SUBJECT: **NEW VEHICLE DEMONSTRATION / DELIVERY HOLD -
Safety Recall 23S65 – Supplement #2**

Certain 2021-2023 Model Year F-150 Vehicles Equipped with 9.75" HD Axle – ¾
Float Axle

Rear Axle Half-Shaft and Hub Assembly Replacement – Final Repair

New! REASON FOR THIS SUPPLEMENT

FIGURE 4

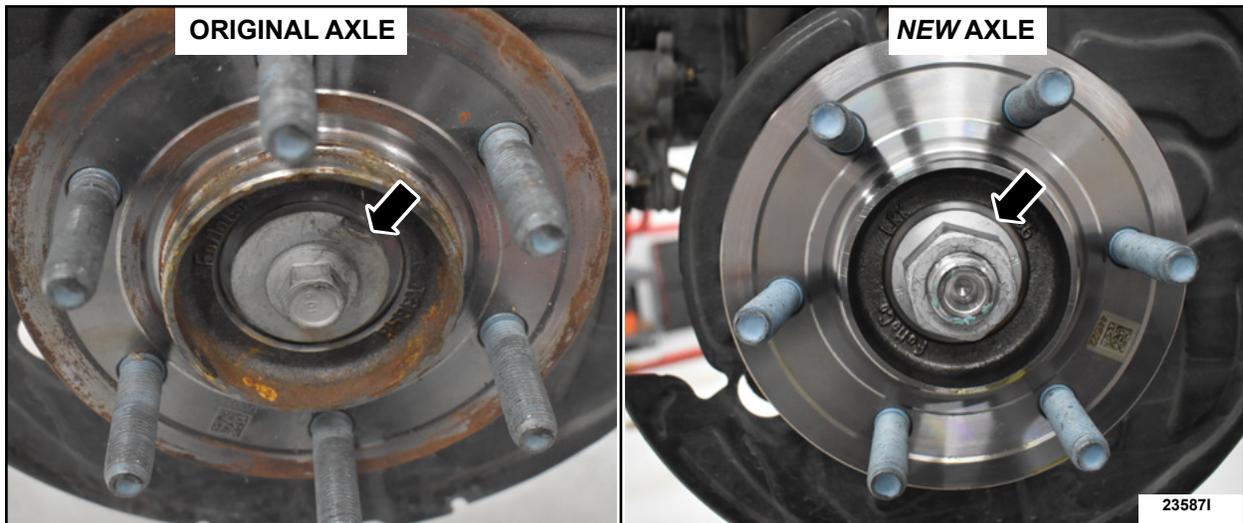
NOTE: The original axle has a bolt in the center to secure the hub to the axle shaft, the new axle is threaded and secured with a nut. See Figure 4.

FIGURE 5

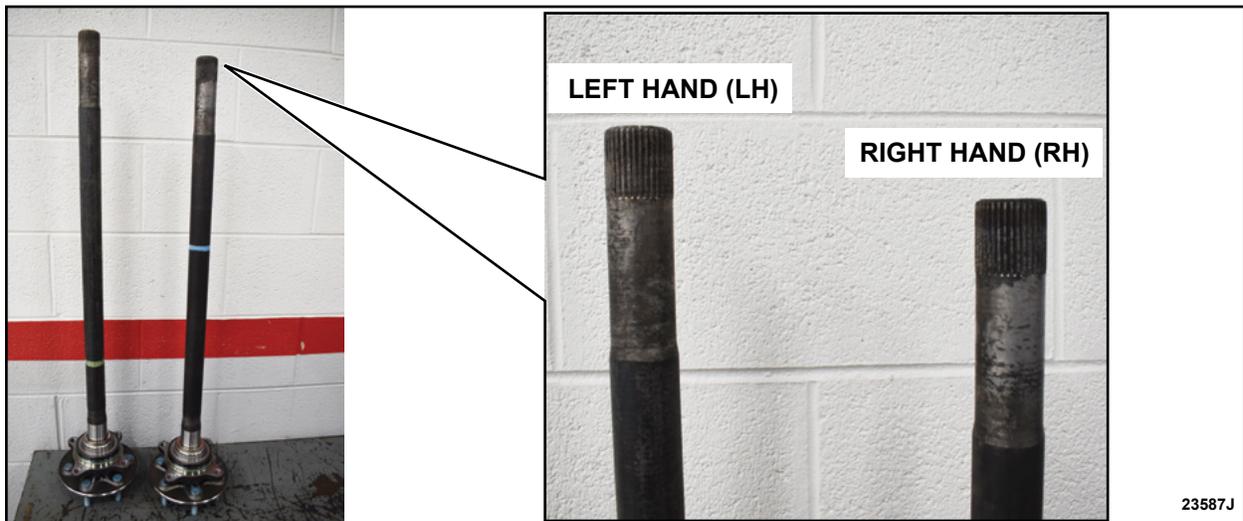
NOTE: The Right Hand (RH) side axle is shorter than the Left Hand (LH) side axle. See Figure 5.
